**ADDENDUM No. 3 – May 2<sup>nd</sup>, 2016**

**BID NO. IFB 16-115, FINANCE PROJECT No. MP 1601 and LS 1601**

**TROPICAL DRIVE AND BARTON ROAD IMPROVEMENTS**

SHEET  
**C100**

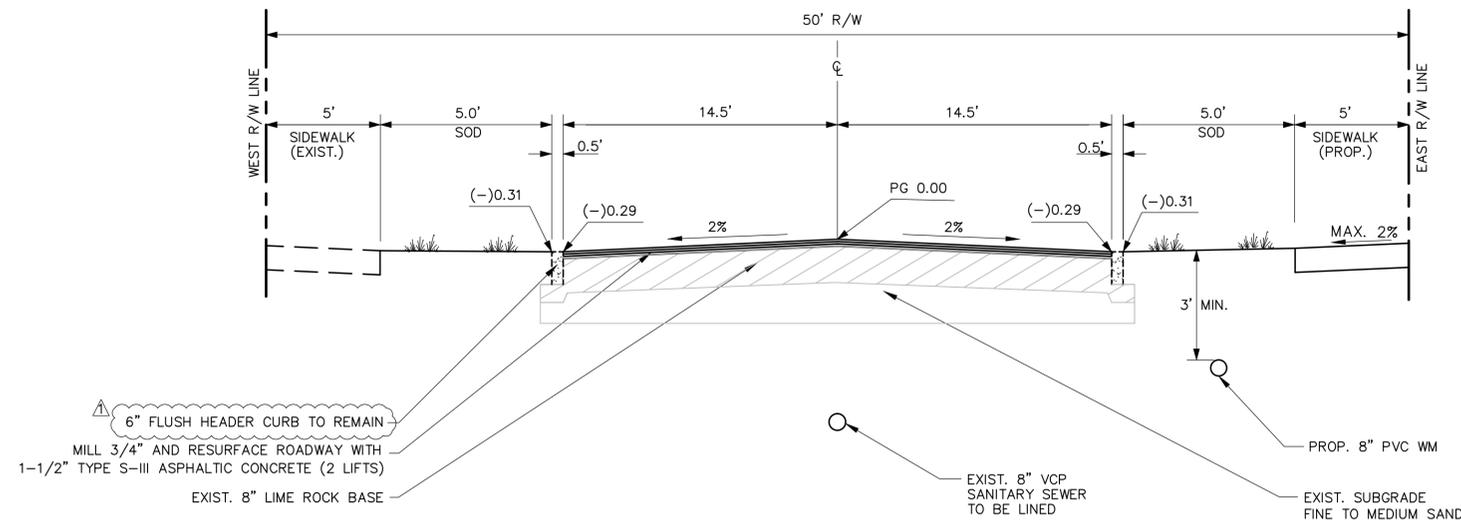
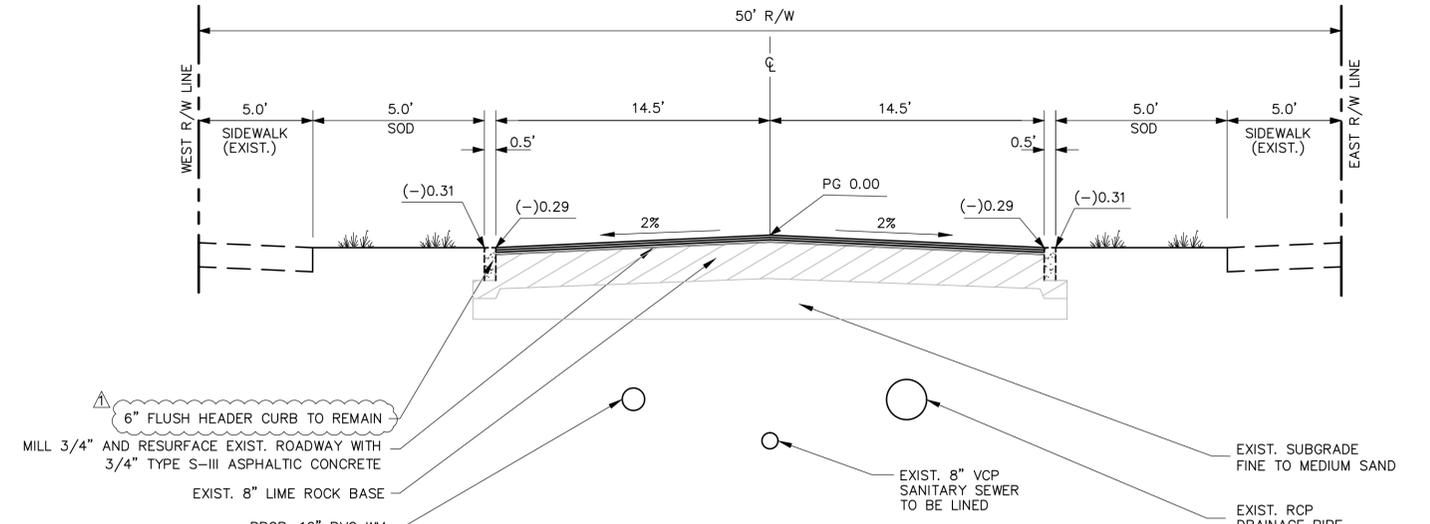
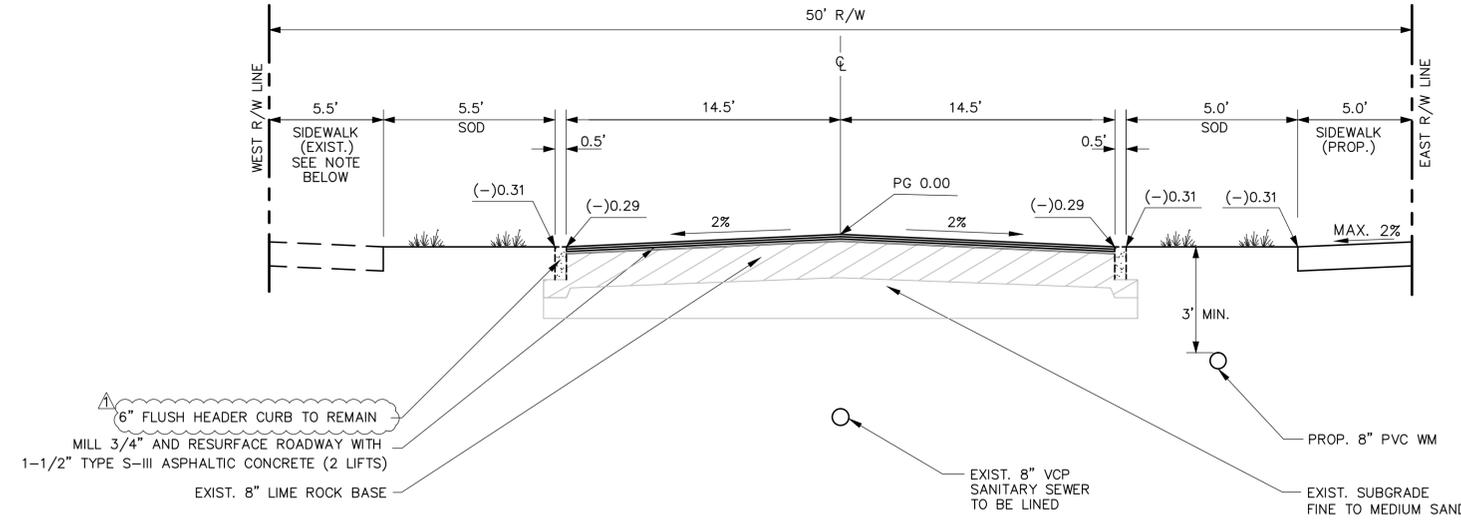
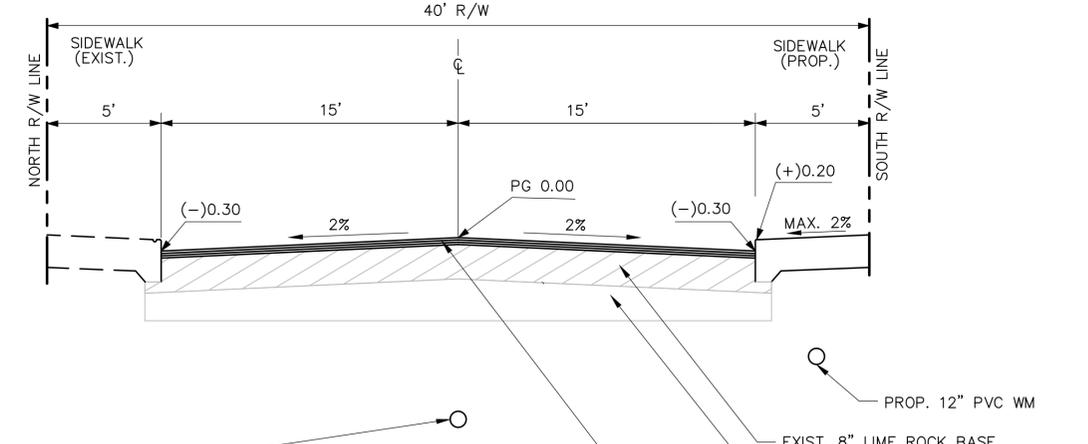
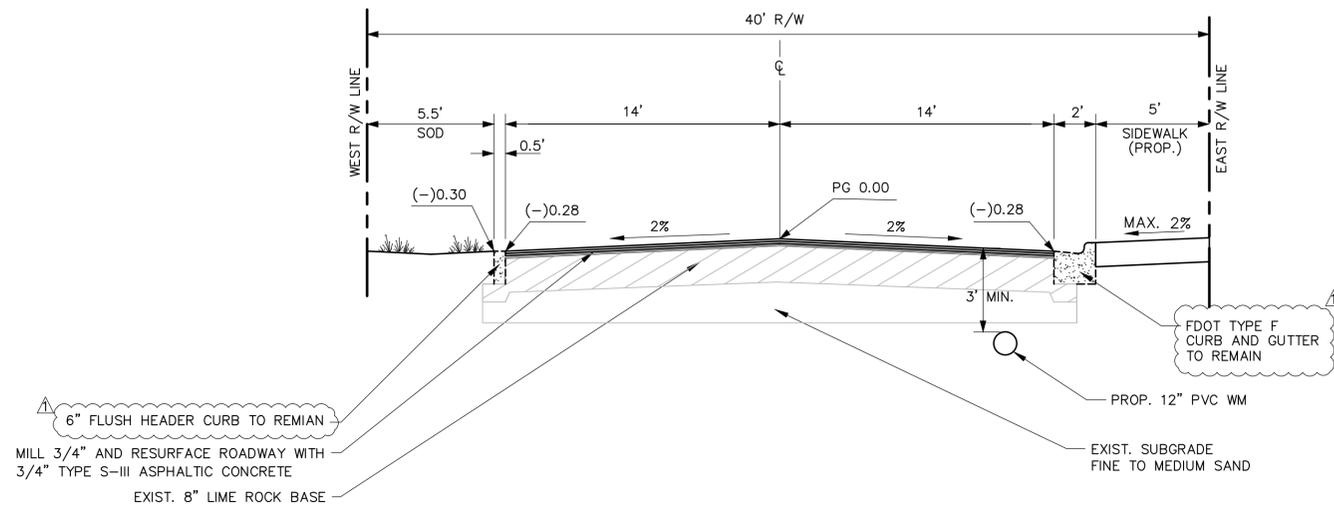
1. The typical sections on Sheets C100 and C101 depict the construction of a 6" flush header curb or curb and gutter on either side of the roadway. Please confirm whether new curbs are proposed or if existing is to remain. If new curbs proposed, please add a line items so that all bidders are sure to include in their price Takeoff of plans shows significantly less 4" concrete sidewalk than bid schedule, has engineer assumed that sidewalk behind 6" drive aprons to be 4"?

**Sheets C100 and C101 were revised to show existing 6" flush header curb to remain. The only header curb to be removed and replaced will be at those locations required for water main installation and at proposed curb ramps. Curb will also be removed at every indicated point on the drawings where the solid gray hatching (Roadway and Curb Reconstruction) meets the existing curb.**
